Änderungsmitteilung (CN)

Product Change Notification

Title [Title] Optimization of the connector pins to the mating connector used in RRC21xx batteries		Date [Datum] 19may2022		Ref. No. [Lfd. Nr.] CN_21_074	
Part Name [Teilebezeichnung]	RRC Article No. [RRC Art-Nr.]	Index	Customer Article No. [Kunden Art-Nr.]		Index
RRC-MC21-90-20	211278	-01

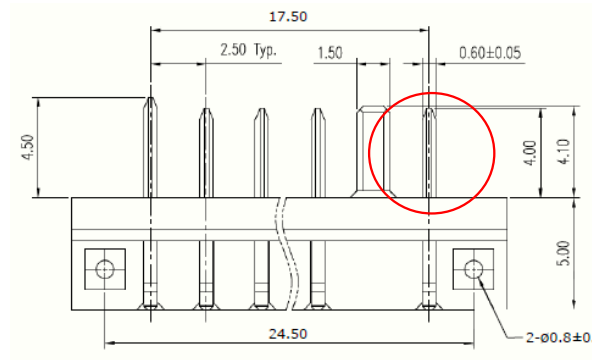
1. Connector optimization:

The pin besides the key-item is slightly shortened to ensure an ideal fit to the mating connector used in RRC21xx batteries:

Please notice the adjusted pin in the red circle on the right side:

Old design (pin length 4.50mm):

New design (pin length 4.00mm):
